Khangela Emoyeni Wind Energy Facility (WEF) – Phase 2

Draft Amendment Report

Reference: 509161
Revision:0

Submission date: 2020/09/07

Figure 5: Proposed amended turbine specifications depicted against the authorised specifications

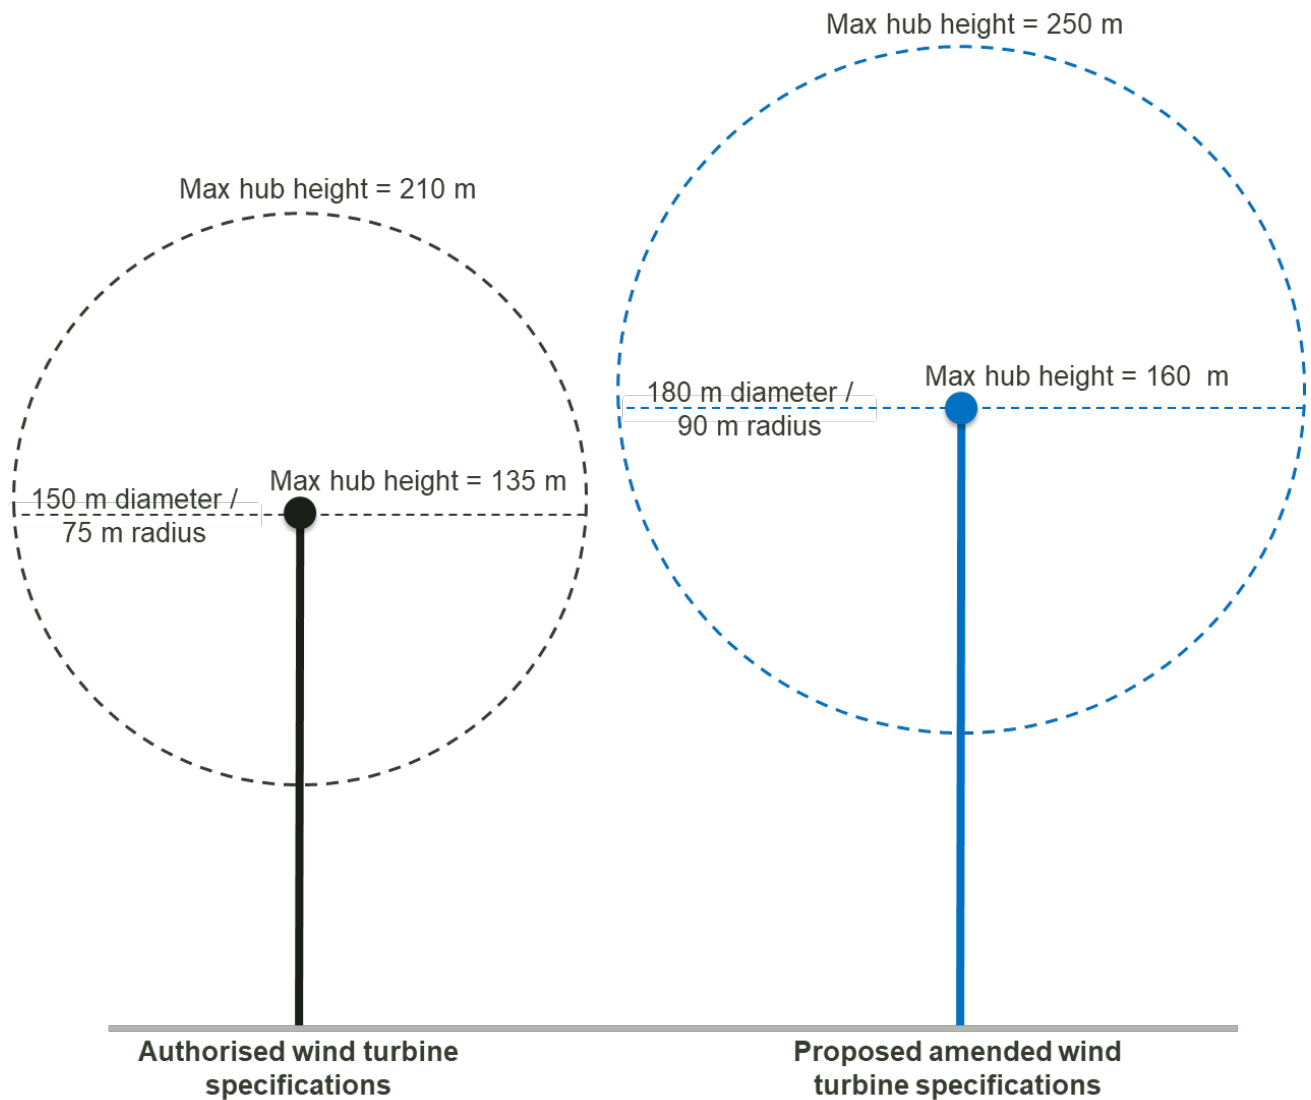
The scope changes are namely based on the new, bigger turbines which are more efficient, resulting in a slight change to the environmental footprint. Windlab aims to complete the project in order to supply electricity to the National Government and in turn local and nation-wide communities at the least economical cost per kWh, whilst limiting the impact on the receiving environment as far as possible.

Component / Specification	Authorised	Proposed change
Site access	Existing farm access tracks and watercourse crossing will be upgraded. Internal roads: 9 m width during construction. Reduced to 4 - 6 m during operations. Internal road length: 35.8 km	Existing farm access tracks and watercourse crossing will be upgraded. Internal roads: 12 m width during construction Reduced to 4 - 6 m width during operations Internal road length: 29.3 km
Generation capacity	147 MW	147 MW
Number of turbines	Up to a maximum of 35	Up to a maximum of 33
Turbine generation capacity	1.5 – 4.5 MW	Up to 10 MW
Hub height from ground level	Up to 135 m	Up to 160 m
Rotor diameter	Up to 150 m	Up to 180 m
Blade length	75 m	Up to 90 m
Blade tip height	210 m	Up to 250 m
Area occupied by substations	200 x 250 m single storey substation compound	No amendment required.
Capacity of substation	33/132 kV	No amendment required.
Temporary construction hardstand area per turbine	60 x 30 m (1,800 m ²)	95 x 23 m (2,185 m ²)

Figure 6: Proposed amended site layout for Khangela Emoyeni WEF

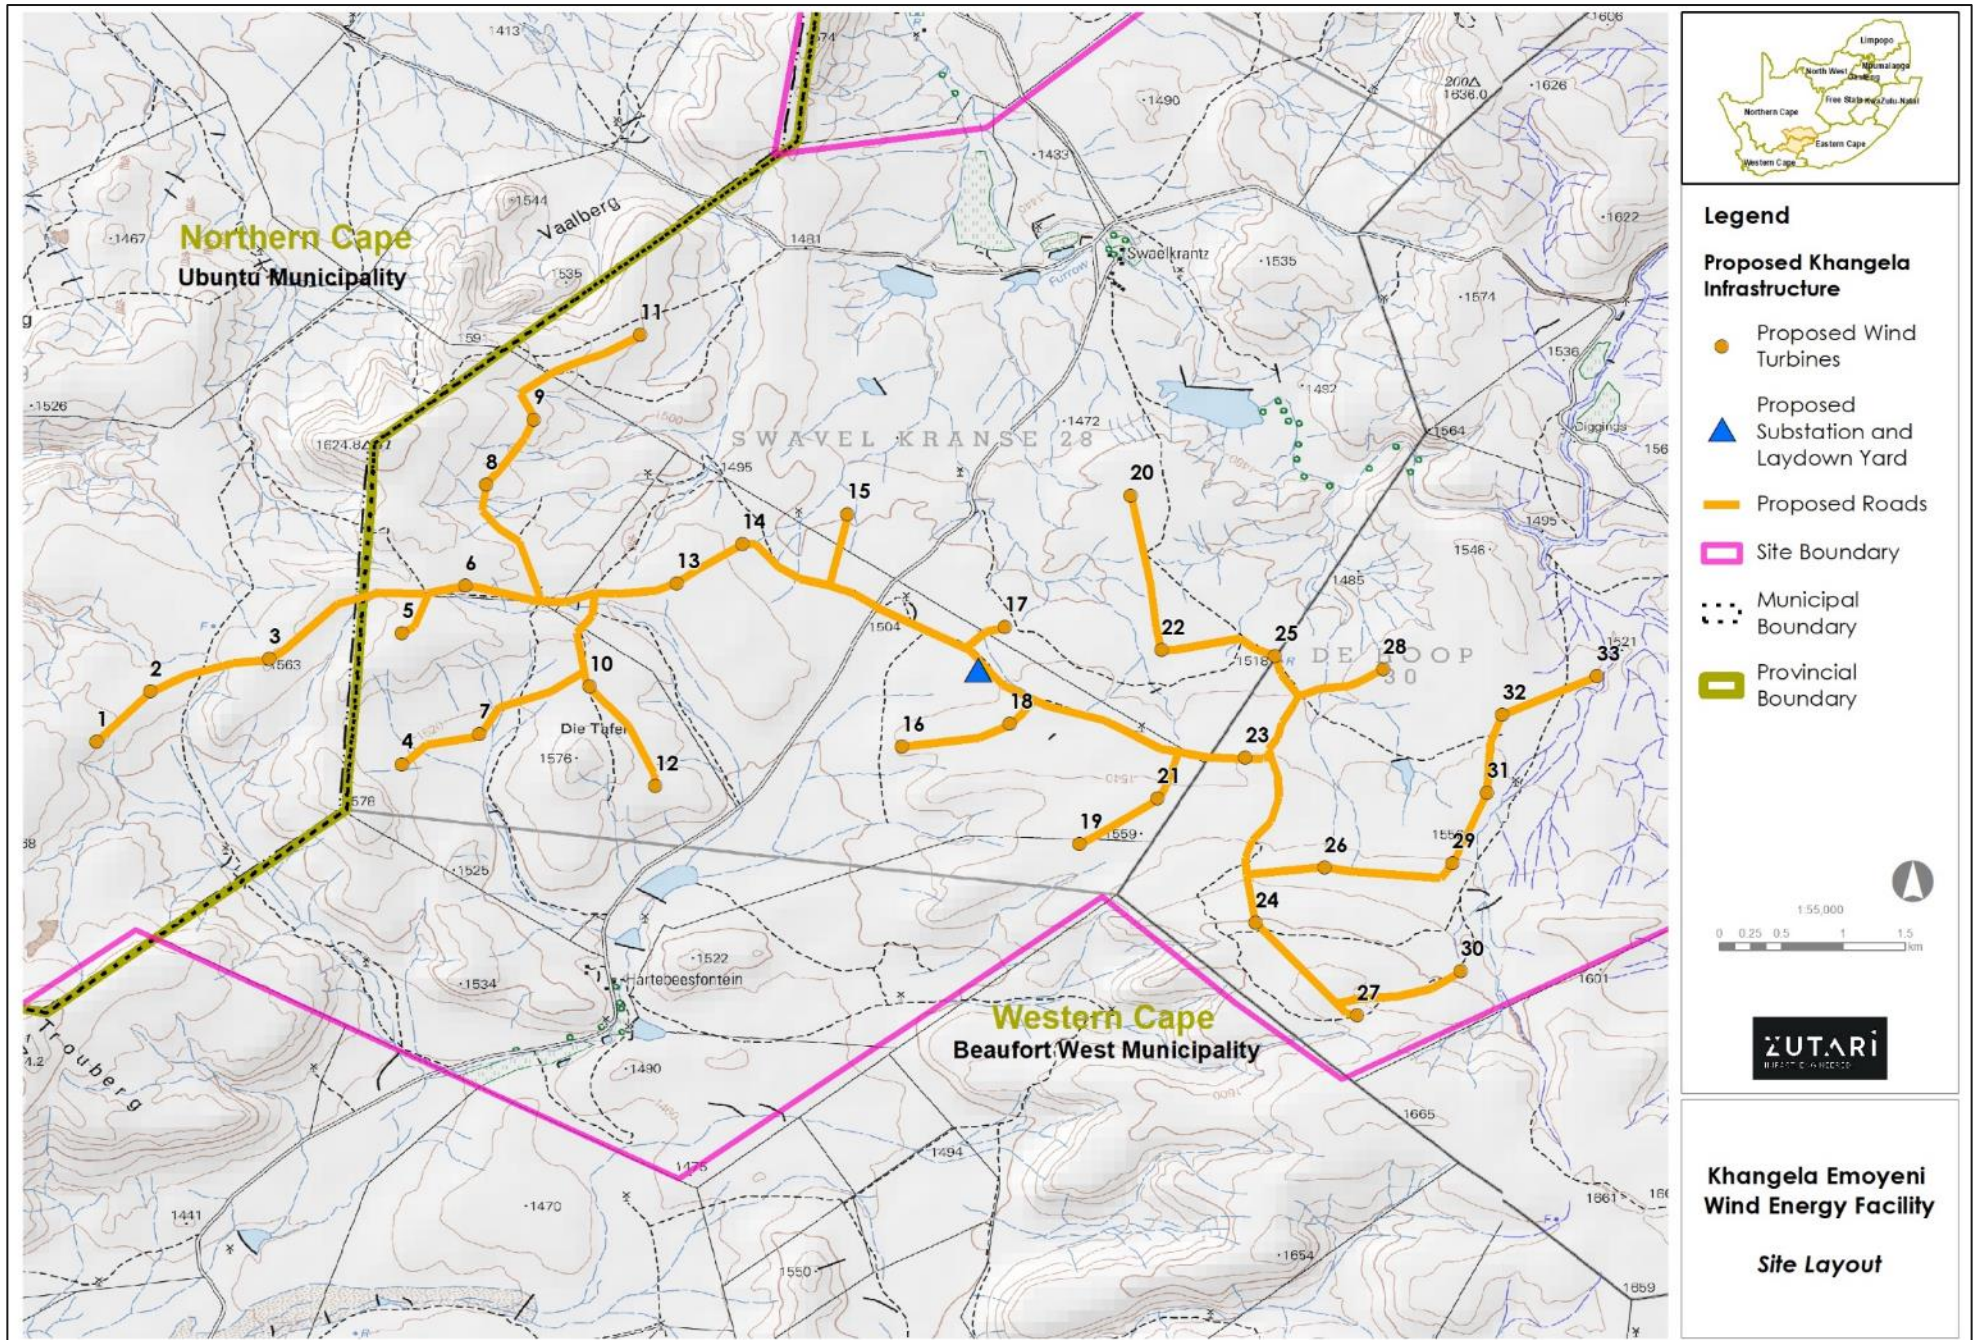
In order to optimise the layout for the fewer, larger turbines, the location of some turbines has changed, along with the associated infrastructure, namely the alignment of the internal roads and cables. Hardstands at each turbine will permanently increase in size and roads will be slightly wider during construction to cater for the transport of the larger turbines. The revised turbine locations and associated infrastructure are all located within the site boundary as considered in the original EIA. The substations and grid connection locations will remain unchanged.

Figure 10: Ecological sensitivity map of the proposed amended Khangela Emoyeni site (2020)

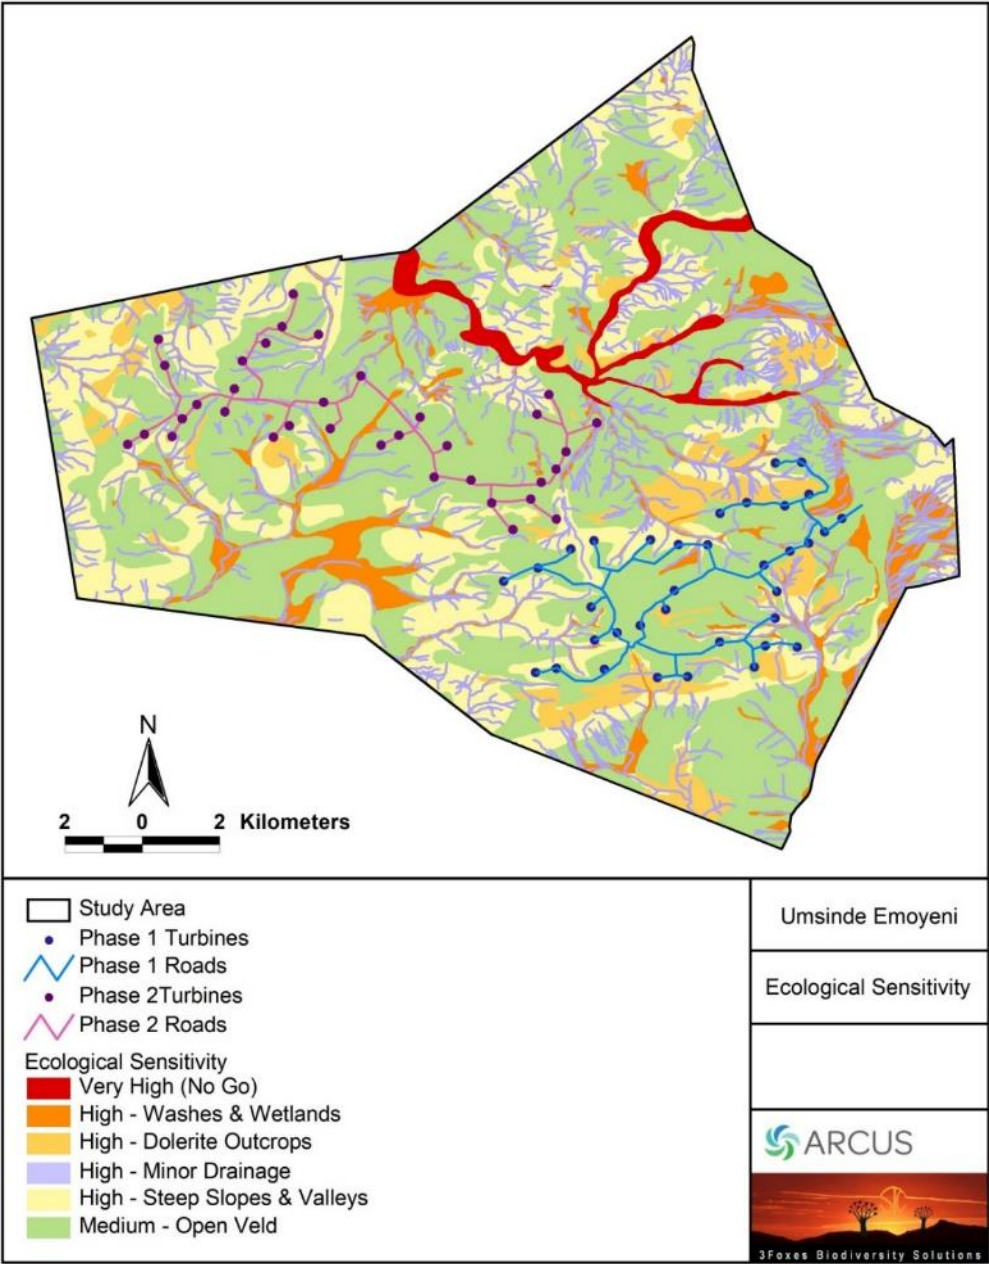
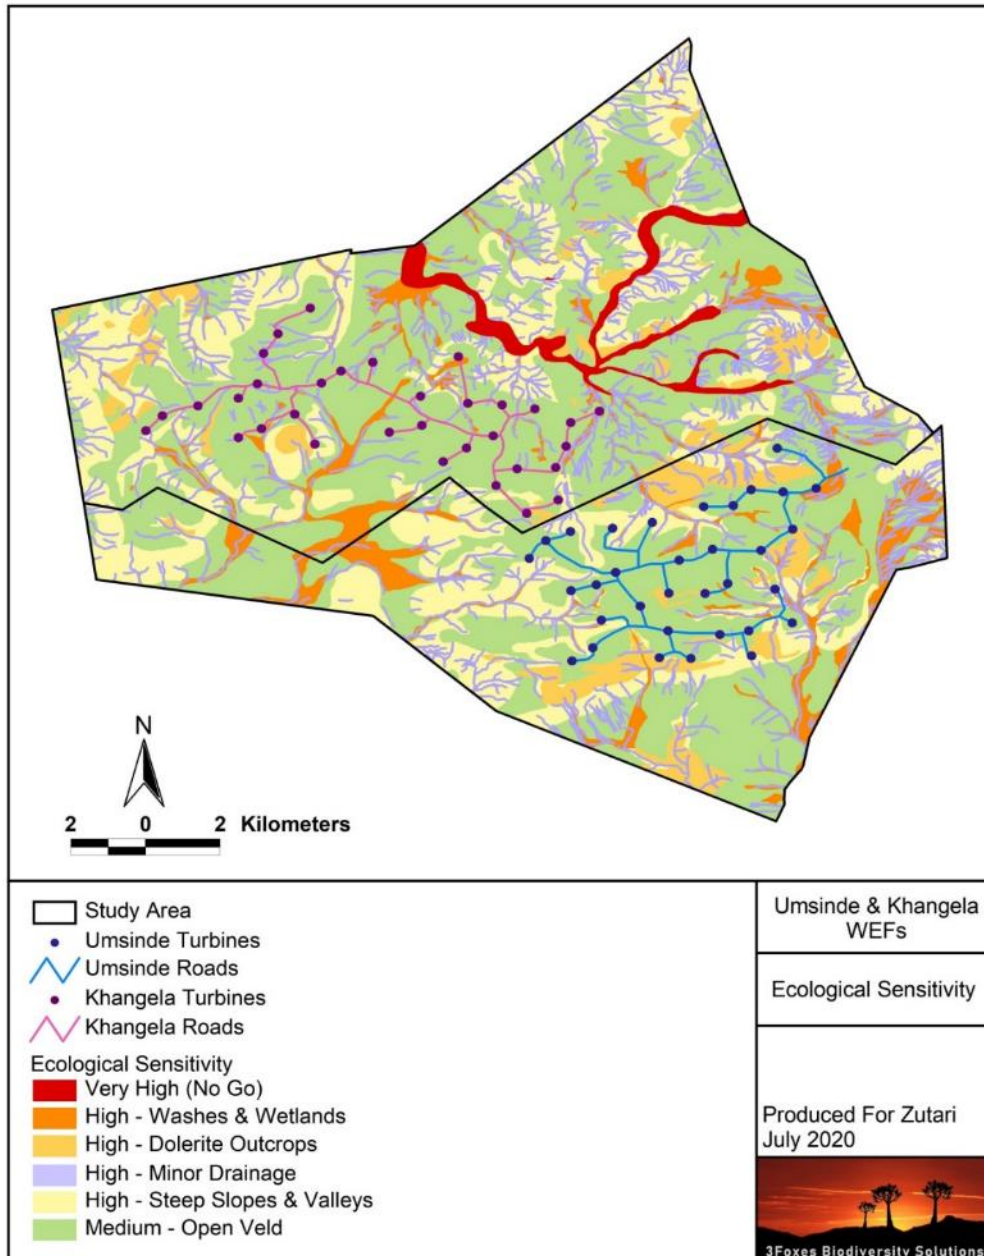
From an ecological perspective the change of greatest potential impact is the relocation of turbines from their original assessed positions and an increase in the footprint associated with each turbine. However, it is important to note that the final increase in the development footprint would depend on the size and hence also the number of turbines used. Depending on the scenario, this would result in a range of footprints from 50-54 ha during construction, reduced to 26-29 ha during operation. A review of these changes and their ecological implications indicates the following outcomes:

There have been significant changes to the CBA mapping in the area since the original EIA study was conducted. In 2018 the development was within CBAs and Ecological Support Areas (ESAs). Under the current revised layouts there are no turbines within these areas.

Figure 11: Avifaunal sensitivity map (Arcus, 2020)

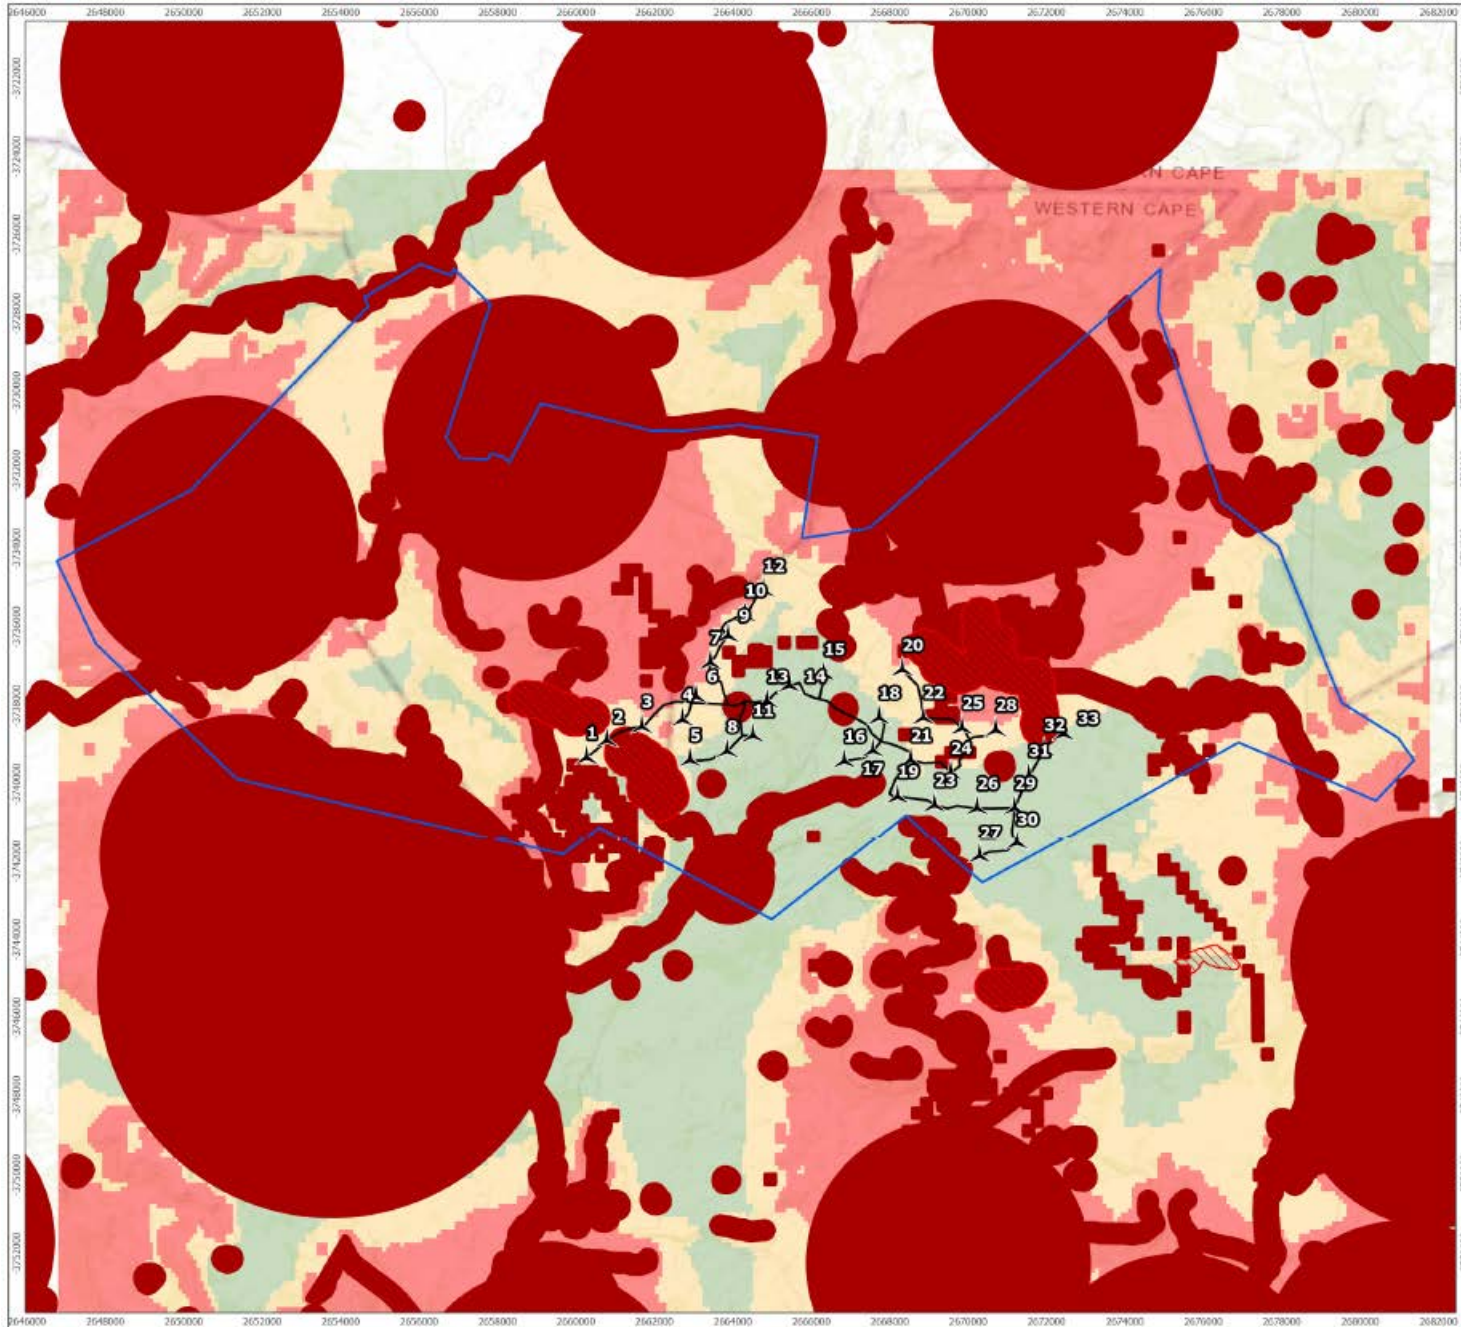
The Verreaux's Eagle Risk Assessment Tool (VERA) model was used to model areas of particular sensitivity to Verreaux's Eagle and identified additional no-go buffers to inform the site layout. Additional rocky ridge buffers have also been included based on the Verreaux's Eagle guidelines as shown in the revised avifaunal

sensitivity map (Figure 11 below). The incorporation of the VERA risk model into the avifaunal sensitivity map has **improved the confidence level of the assessment and further reduced the potential risks** imposed on Verreux's Eagle by the proposed development.

- The EMPr must be updated to include the revised avifaunal sensitivity map.
- Areas identified by the updated sensitivity map as 'no-go' areas for the placement of turbines and overhead powerlines should be explicitly stated as such in the EMPr.

- The final layout must be informed by the updated avifaunal sensitivity map and turbines that fall inside the revised 'no-go' areas must be moved to lower sensitivity areas or removed completely from the layout (this has been done).
